CPED STAFF REPORT

Prepared for the Heritage Planning Commission
Agenda Item #3
August 25, 2015
BZH-28750

Property Location: 101 1st Avenue N
Project Name: 101 1st Avenue N Townhomes
Prepared By: Kimberly Holien, Senior Planner, (612) 673-2402
Applicant: Shorenstein Realty Services
Project Contact: Carl Runck, Ryan Companies
Ward: 3
Neighborhood: North Loop
Request: To construct a residential structure with 13 attached townhome units in the Saint Anthony Falls Historic District.

3 TOWNHOMES - NORTH ELEVATION
A3.11 3/32" = 1'-0"

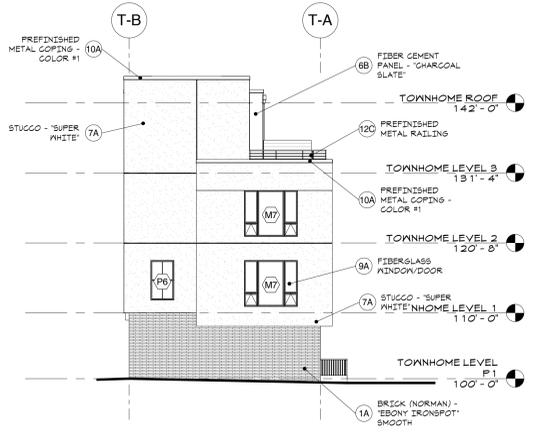
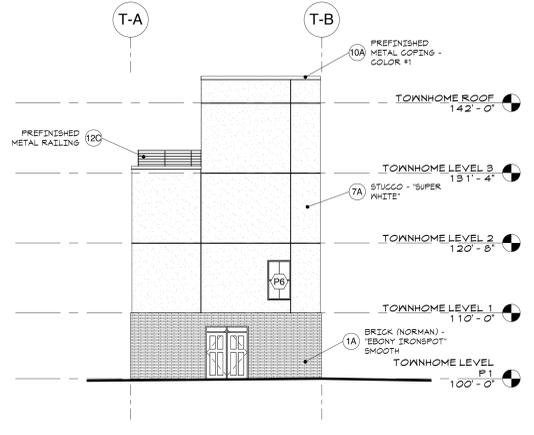
The north and south ends of the building will be brick on the first floor and white stucco on the upper floors to match the front of the building. Please note that the staff review of the site plan review application will include a condition of approval for additional windows on the south elevation to break up blank walls and meet the minimum window requirements.

1 TOWNHOMES - WEST ELEVATION
A3.11 3/32" = 1'-0"

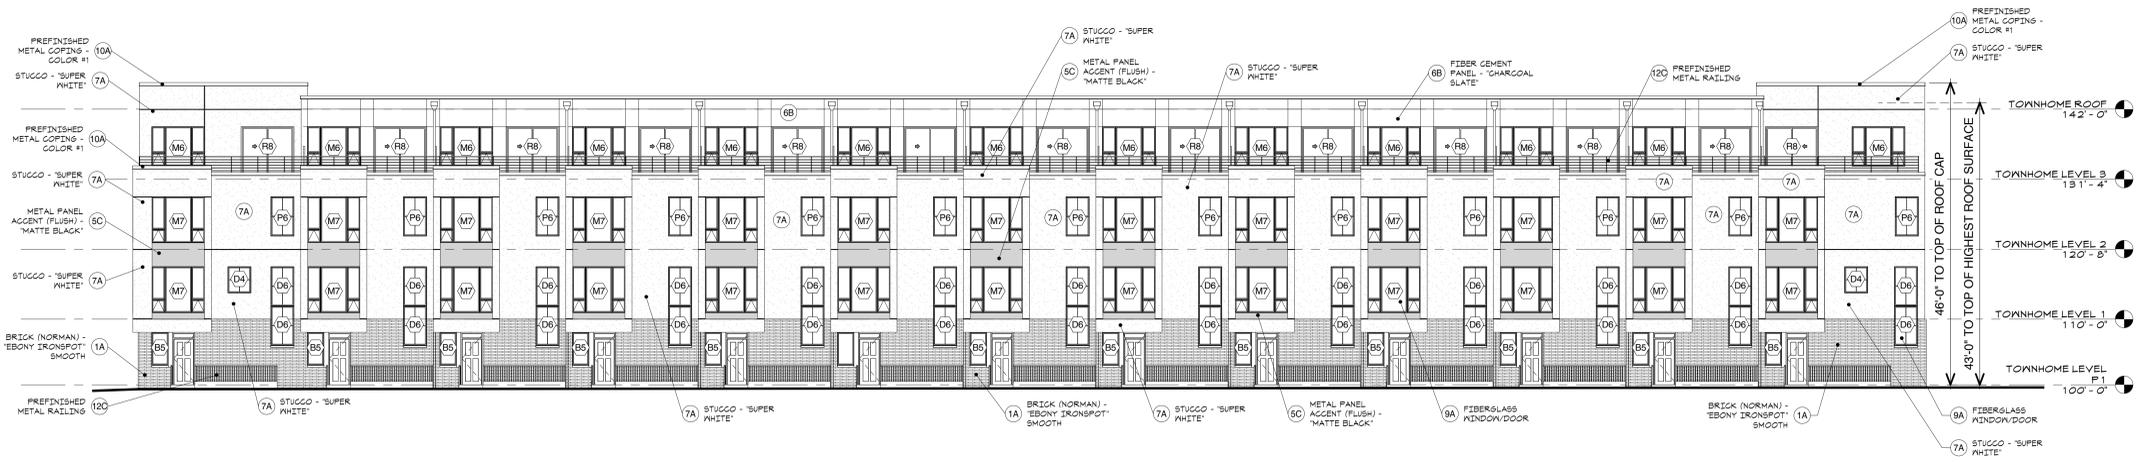
Staff comment: The building is new construction with contemporary architecture and roof decks proposed on the fourth floor. The applicant is proposing prefinished metal railings along the edge of the roof across the entire front of the building. Staff recommends that the design of the railings be more transparent to reduce their visibility and simplify the façade.

Staff comment: On the front (west) elevation, the first floor of the building will be dark brown brick with a traditional modular dimension. The second and third floors will be white stucco with dusty charcoal metal panel in horizontal bands between the center windows. With the exception of the corner units, which are stucco, the recessed fourth floor will be charcoal gray fiber cement. The applicant is proposing three primary exterior materials and the design guidelines call for one primary and one accent materials. Additionally, the fiber cement is not called out as a permitted material. As a condition of approval, staff recommends that the fourth floor utilize the same metal panel that is proposed as an accent material on the second and third floors in lieu of fiber cement on the fourth floor. Reducing the number of materials and eliminating the fiber cement will be more consistent with the design guidelines.

Staff comment: The overall design of the building is contemporary and contemporary materials are proposed. As noted above, the applicant is proposing three primary materials on the front elevation and introducing two additional materials on the rear elevation. Additionally, fiber cement panel is proposed and said material does not have exemplary detailing as called for in the design guidelines. As a condition of approval, staff recommends that the fourth floor utilize the same metal panel that is proposed as an accent material on the second and third floors on the front elevation. Staff is also recommending that the white fiber cement on the back side of the building be replaced with white stucco and the burnished block match the color of the proposed brick on the rear elevation. Staff further recommends that the gray fiber cement panel on the rear elevation be replaced with the same metal panel proposed on the front of the building.

Staff comment: Windows are vertically proportioned and evenly spaced. Each of the end units has one extra window on the second floor that breaks the rhythm. The tops of the windows are in alignment horizontally across the building.

3. The railings on the fourth floor shall be modified to be more transparent, consistent with the *Saint Anthony Falls Historic District Design Guidelines*.

1 TOWNHOMES - EAST ELEVATION
A3.12 3/32" = 1'-0"

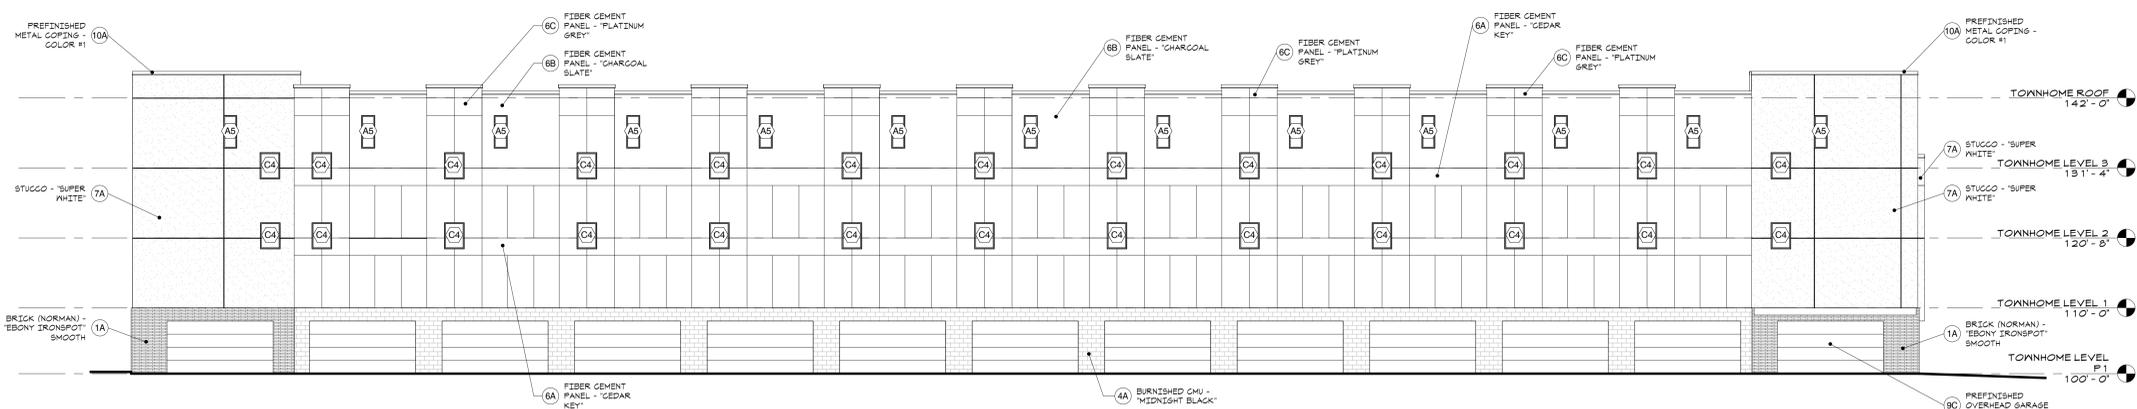
Staff comment: The proposed townhome development is articulated into individual units each approximately 23 feet in width. The character area does not have specific guidance for building width and the brick building on the adjacent site at 133 1st Avenue N provides the only context on the block at 25 feet in width. The articulation techniques implemented by the applicant include material changes and projections. These techniques are expressed consistently across the front of the building. As noted above, staff is recommending that the same metal panel proposed as an accent material on the front elevation be used on the fourth floor to simplify the material palette as called for in the design guidelines. Staff is also recommending that the fiber cement on the back side of the building be replaced with the stucco that is proposed on the other three elevations.
